RFT 26-031 Milton # 13 Elementary School and Child Care Facility

PROJECT NO. 22124
HOSSACK & ASSOCIATES ARCHITECTS

ADDENDUM NO. 4

Issued February 26, 2026

GROUND FLOOR POWER & SYSTEMS PLAN

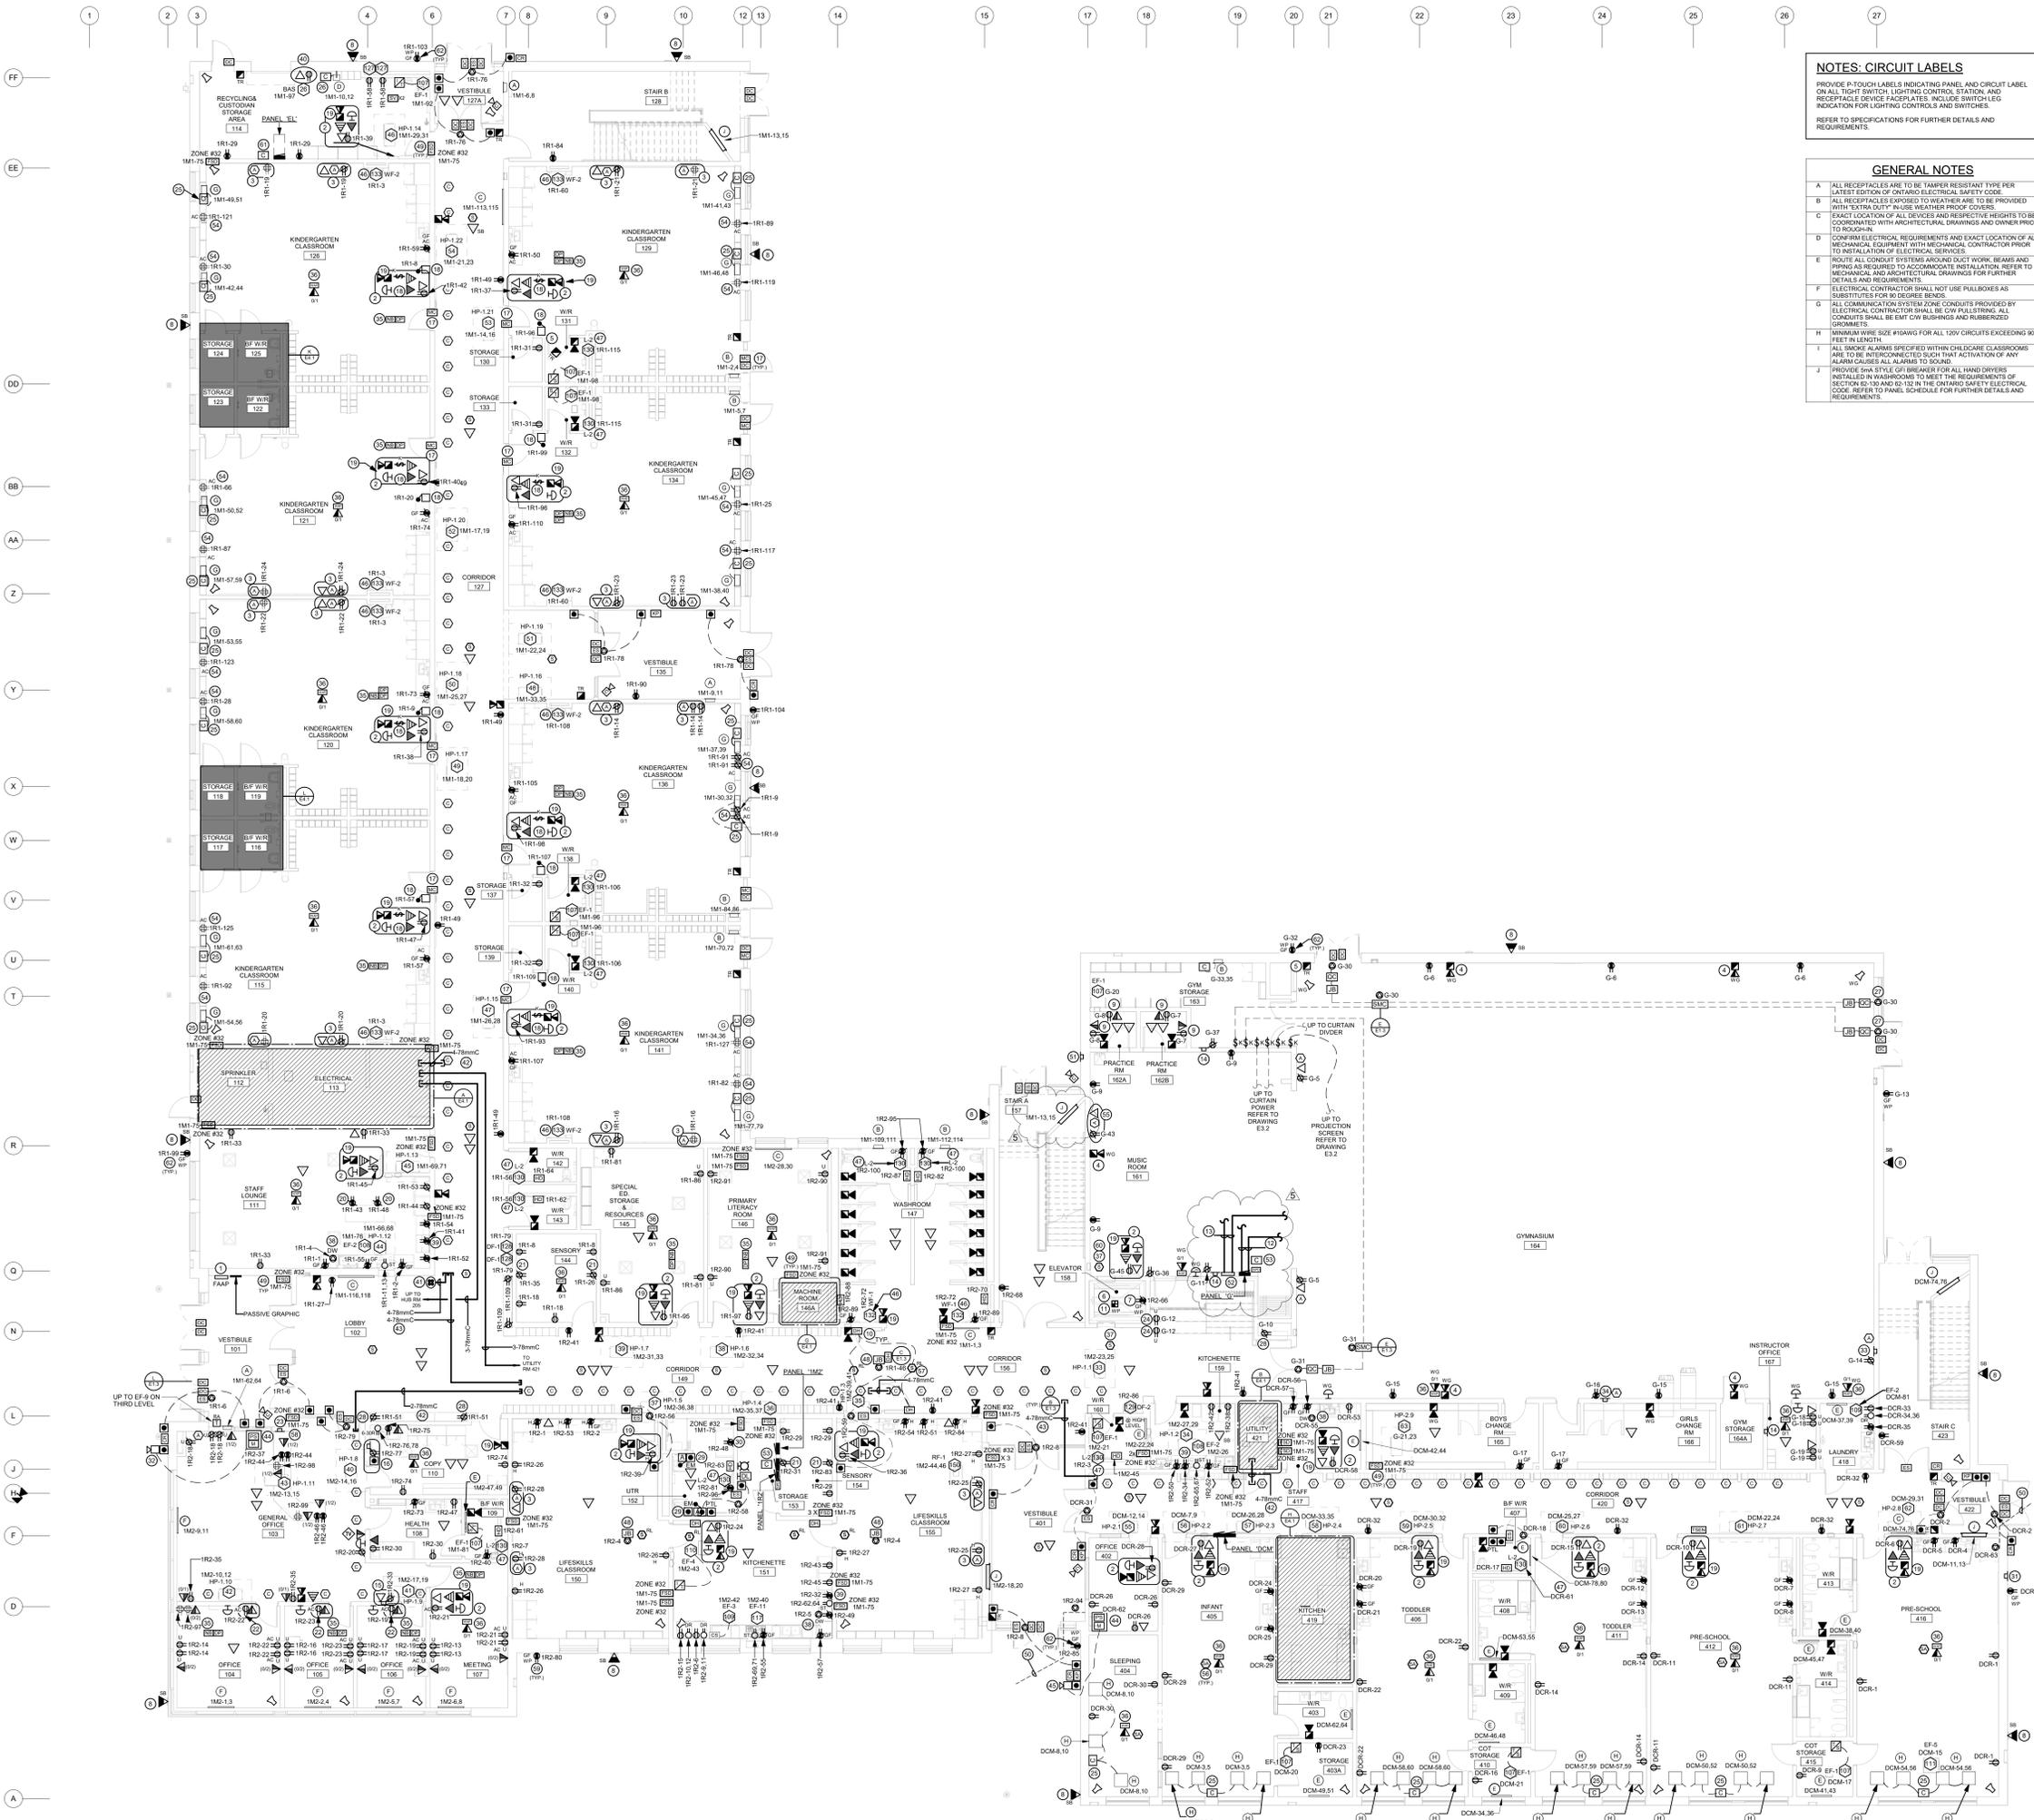
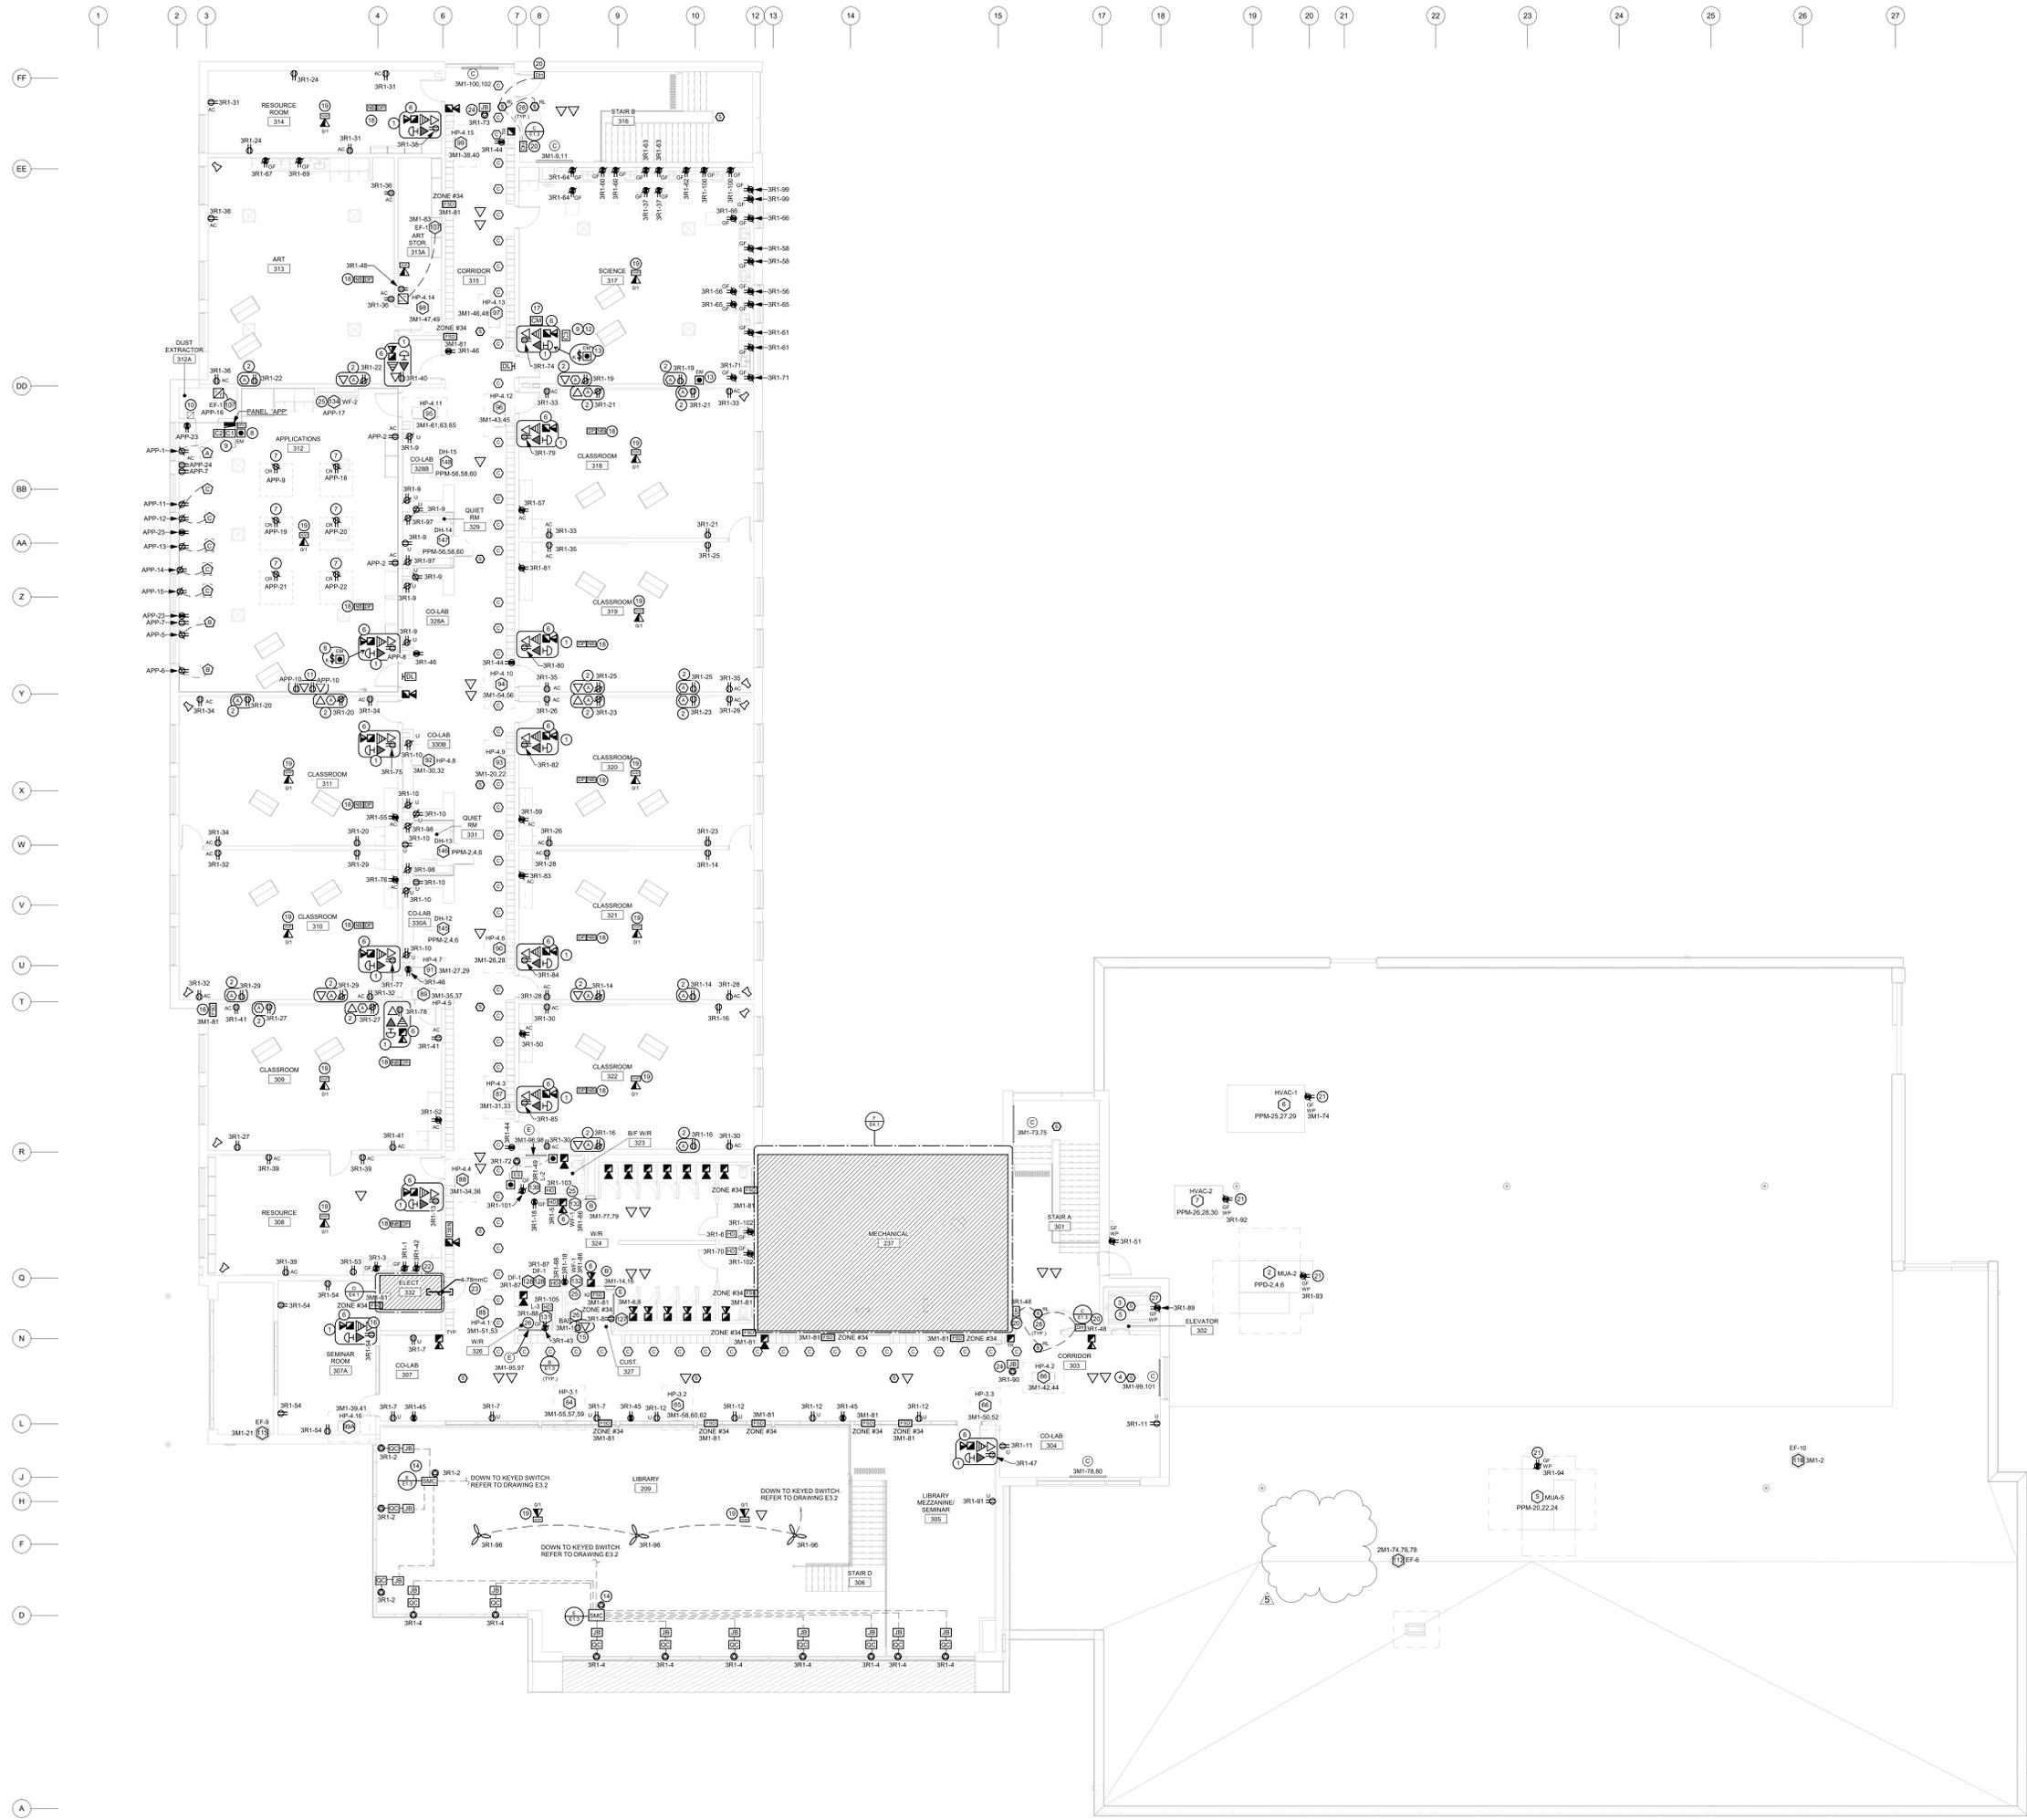
- 2.0 Reference Attached Reissued Drawing E3.1
- .1 Wall heater within Stair A is to be relocated to angled wall to suit architectural changes.
 - .2 Wall added behind panel G and lighting control panel to maintain fire separation, shift devices as required.

THIRD FLOOR POWER & SYSTEMS PLAN
SCALE: 1:100

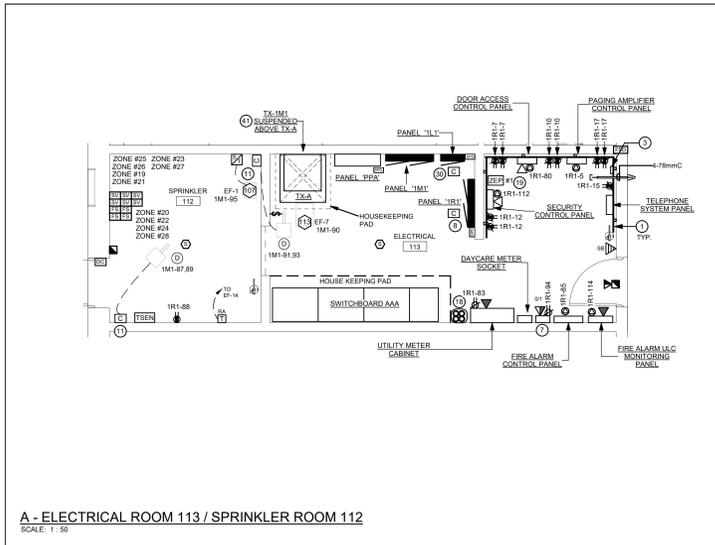
- 3.0 Reference Attached Reissued Drawing E3.3
- .1 Remove rooftop condensing unit CU-2 and adjacent rooftop maintenance receptacle to suit mechanical changes. Label existing breakers as spare.

H - KITCHEN 419
SCALE: 1:50

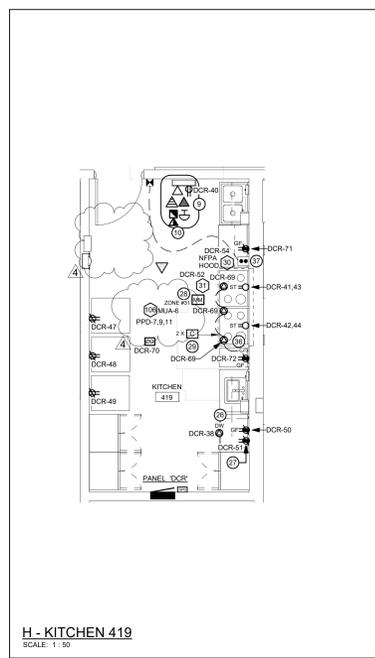
- 4.0 Reference Attached Reissued Drawing E4.1
- .1 Remove DH-1 within Kitchen 419. Revise breaker to 40A-3P breaker to feed new MUA-6.
 - .2 Provide power to new MUA-6 as per attached reissued drawing E4.1.
 - .3 Remove HP6.1 completely. Label existing breaker as spare.
